VILLAGE OF MOUNT HOREB

PLAN COMMISSION AGENDA **Wednesday, March 25, 2026 at 7:00 PM**

Re: Concept Review - Proposed CSM to Split an Existing Lot into Two New Lots and Site Plan Review for Two 2-Unit Duplexes at 1348 Field Court for Nick Olday.

SW1.1

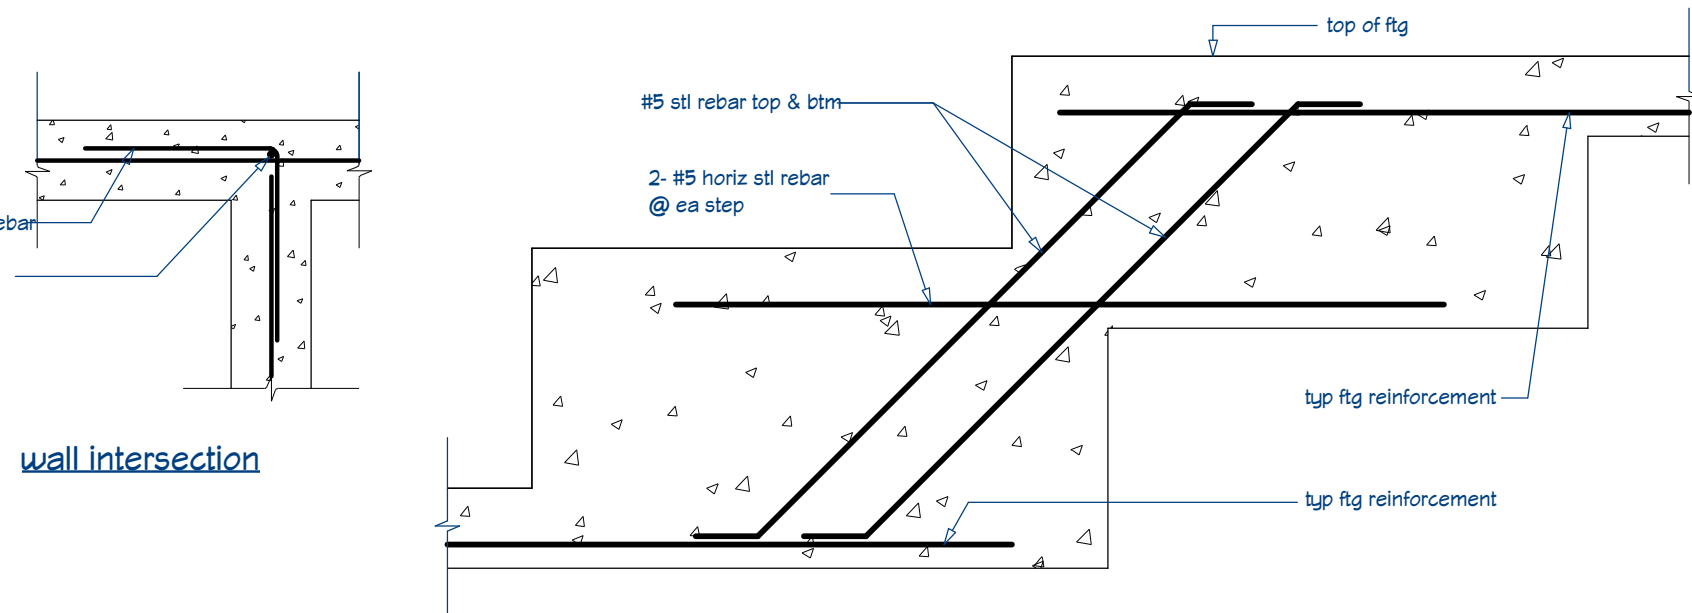
- Pavement setbacks:
 - Met for Lot 1 (the existing shared driveway crosses the property line and is not proposed to change)
 - Not met for Lot 2:
 - The rear patio pavement along the western property will need to be reduced to meet the 5' minimum side yard setback for pavement.

- Trash: There is no trash enclosure shown on the plan set, so it is assumed that each unit will have individual trash bins that are stored within each garage. If that's not the case, then a screened enclosure will be required.

- An Exterior Lighting Plan and Landscaping Plan will be required as part of the formal Site Plan package.
